M2 Junction 1 South Eastbound Merge Safety Review

Document no: B2432000-MedwayLP-M2J1-SR
Revision: 1

Medway Local Plan
21 October 2025

Client name: Medway Council
Project name: Medway Local Plan
Client reference: - **Project no:** B2432000
Document no: B2432000-MedwayLP-M2J1-SR **Project manager:** Jessica Denny
Revision: 1 **Prepared by:** Nicola Childs
Date: 21 October 2025 **File name:** B2432000-MedwayLP-M2J1-SR
Document status: For Issue

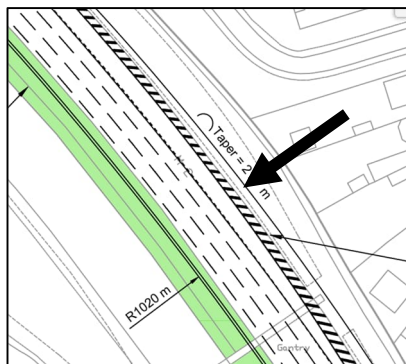
Location: Within the proposed area of nearside widening along the two-lane interchange link, in the vicinity of the A2 bridge.

Summary: The design of the A2 bridge structure may result in reduced height clearance close to the bridge pillars, which could increase the potential for collisions involving high vehicles striking the bridge following widening.

Description: No information on levels or available headroom was available to the review team at this early design stage, and although the existing carriageway has sufficient clearance, it was noted that the design of the structure appears to taper downwards close to the support pillars.

Following widening, traffic in the nearside lane will be passing closer to this area than at present, and in the absence of details of height clearance, there is concern that proposed changes to camber and carriageway

levels in the widened lane may result in insufficient headroom and an increased risk of high vehicles striking the bridge.

The drawing provided also notes the need to confirm there is sufficient headroom for the carriageway widening.

Recommendation: Survey the working height of the structure to understand its vertical constraints and design the carriageway levels accordingly to provide sufficient clearance for all traffic and adequate protection for the bridge structure.

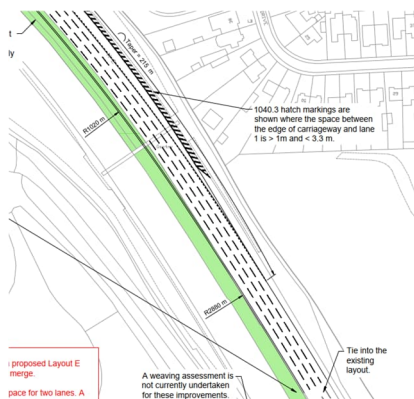
Location: At the south eastern end of the J1 merge, where the M2 J2 1/2 mile gantry is located.

Summary: The proximity of the gantry to the junction 1 taper merge may increase the potential for late lane changes and side swipe collisions downstream.

Description: Following implementation of the works, the existing 1/2 mile gantry for J2 will be located within the area where traffic will be merging from the interchange link at J1. This may result in merging drivers concentrating on merging rather than on the information provided on the direction signing, which could result in missing the gantry information and a failure to appreciate that the nearside lane will shortly become a dedicated lane for traffic exiting at Junction 2. The next gantry is located 1/4 mile from the exit.

Failure of merging drivers to read and appreciate the direction information provided could increase the potential for last minute lane change manoeuvres downstream, and an increased potential for involvement in side-swipe collisions.

Recommendation: Provide additional driver information, located appropriately to give drivers sufficient time to safely read, comprehend and position themselves appropriately, in preparation for the J2 diverge.

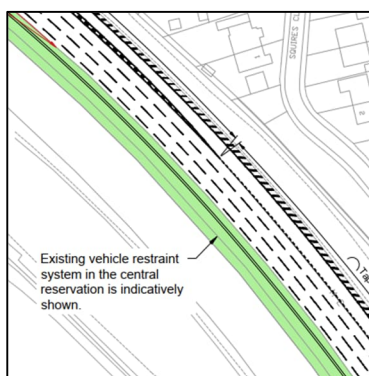
Location: South eastbound M2 mainline, between the end of the nearside merge lane and the start of the dedicated exit lane for M2 Junction 2.

Summary: Failure to provide sufficient weaving distance between the end of the J1 merge and the start of the J2 diverge may increase the potential for last minute lane changes and side swipe collisions on the approach to the J2 exit.

Description: The proposals include a change to the merge type provided on the south eastbound M2, such that the nearside lane merges with the M2 mainline over 400m further to the south east than currently (all measurements approximated as no CAD drawings were available).

The dedicated lane for the J2 exit commences shortly afterwards, at the next gantry downstream (seen bottom right in the second image above), although it was not possible to measure the distance between the two points accurately as J2 is not shown on the plan provided. The review team is concerned that drivers merging from J1 but not exiting at J2 wishing to change lanes to the right, and mainline traffic wishing to change lanes to the left in preparation for the exit at J2, will both have less time to position themselves in the correct lane than currently, and will be undertaking conflicting manoeuvres. This could increase the potential for last minute lane changes and an increased potential for side swipe and lane change collisions.

It was noted that a single slight injury collision occurred between the J1 merge and J2 diverge in the five years to December 2023, which involved a vehicle moving to the nearside ahead of the diverge.

Recommendation Provide a layout which gives drivers sufficient time, space and advance information to position themselves appropriately in advance of the downstream junction exit.

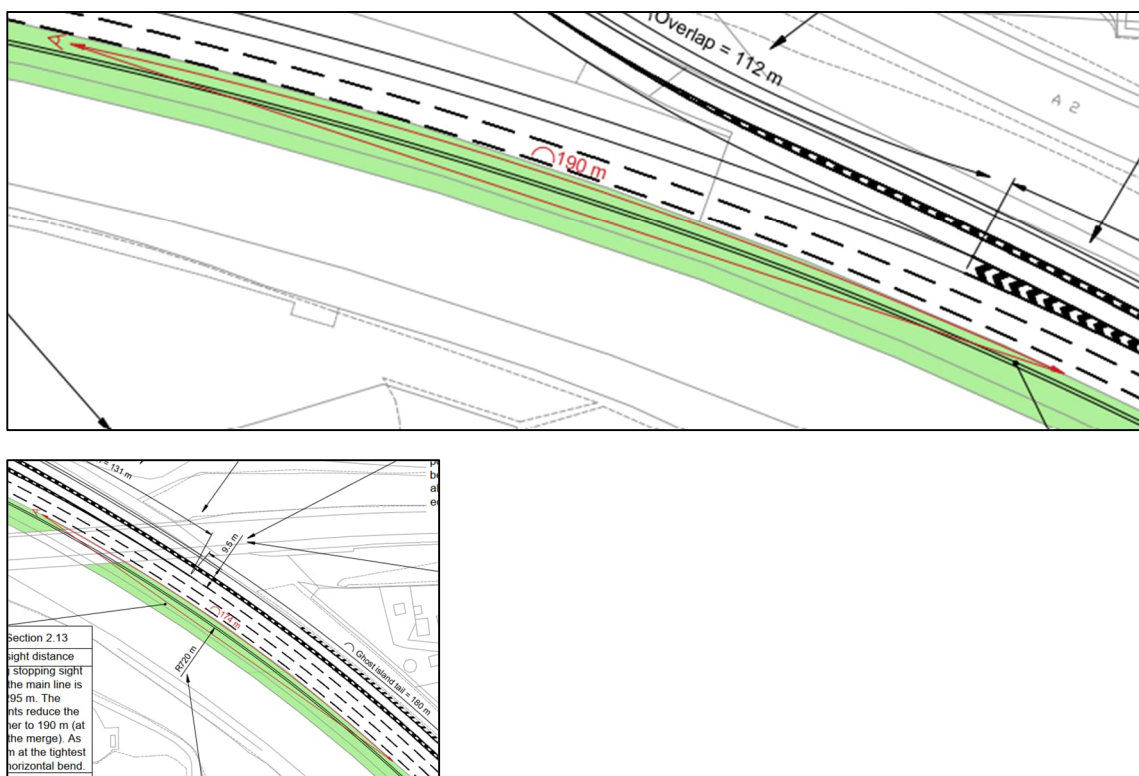
Location: M2 mainline central reserve throughout the entire area subject to widening under the scheme proposal.

Summary: The effect of locating live traffic closer to VRS and lighting columns located within the central reserve, is unknown, and failure to provide adequate protection could increase the severity of injury in the event of a vehicle leaving the carriageway to the offside.

Description: The existing VRS is shown in the central reserve indicatively. The proposals include carriageway widening into the central reserve by up to 4.2 metres on the south eastbound carriageway, bringing the three lanes of the M2 mainline closer to the existing VRS, and street lighting systems within it. The revised setback, working width of the current VRS, and location of lighting columns relative to the working width, and the condition of the existing VRS are all unknown.

The review team is concerned that following widening and relocation of the running lanes closer to the VRS, the VRS may not perform as expected, and lighting columns may also be at increased risk of being struck, resulting in increased severity of injury for vehicle occupants in the event of a collision.

Current standards for road restraint systems (CD 277 para 2.4) require a risk assessment instead of a full Road Restraint Risk Assessment Process (RRRAP) to be undertaken for central reserves of more than 10m wide. The current, and post-widening, widths of the central reserve are unknown and it is also unknown whether a full RRRAP has already been undertaken.

Recommendation: Provide adequate levels of protection for road users within the central reserve, which also ensures that drivers are not at risk from collisions with lighting columns.

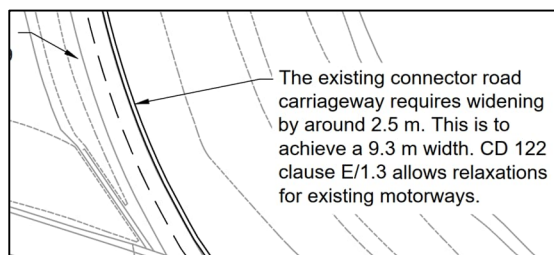
Location: Site wide – A289 diverge, interchange link and M2 mainline

Summary: Failure to update signs and markings for drivers on the interchange link, and M2 mainline following layout changes may result in driver confusion, merging difficulties and last-minute lane changes.

Description: The drawing provided shows a proposed increase in the number of traffic lanes, from one to two, on the interchange link between the A289 southbound diverge and the M2 south eastbound merge, and a change to the layout of the merge to a Layout E - Option 2 merge. However, at this early design stage, there are no proposed changes to the traffic signing on either the diverge, interchange link, or M2 mainline on the approach to the south eastbound merge, which depict the current road layout.

Additionally, there is a proposal for the offside merge lane to be a lane gain, but no ahead arrows are proposed at this early stage, to reinforce the message to drivers that they do not need to change lanes to the right on merging.

Recommendation: Include appropriate changes to signing, markings and driver guidance to reflect the new layout and guide drivers safely through the merge, as the design progresses.

Figure 2-11 Diagram 1040.5 (S11-4-26) End of hard shoulder

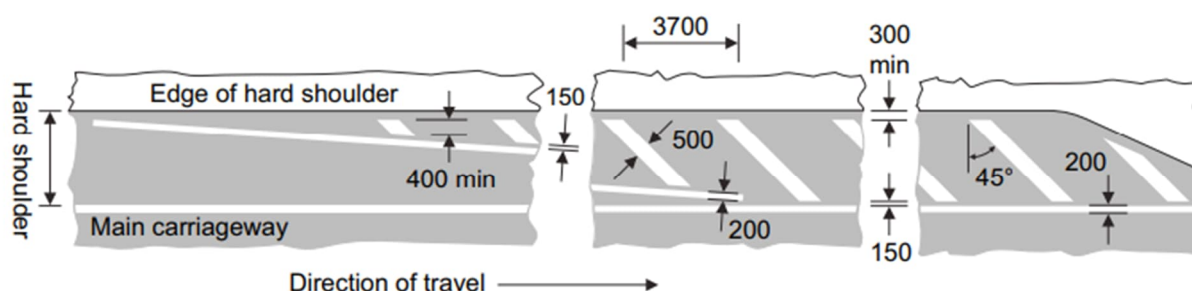
Location: Adjacent to the nearside lane towards the south eastern end of the J1 merge.

Summary: Hatching in the nearside hard strip is rotated incorrectly which may cause driver confusion.

Description: Hatched markings to Diagram 1040.5 of the Traffic Signs Regulations and General Directions is shown on plans provided, located in the nearside hard strip upstream of the commencement of the M2 hard shoulder where the width is insufficient to accommodate a hard shoulder. The chevrons are shown rotated incorrectly. An extract from Chapter 5 of the Traffic Signs Manual is shown below.

Recommendation: Provide all road markings in accordance with design guidance and standards to minimise the potential for driver confusion.
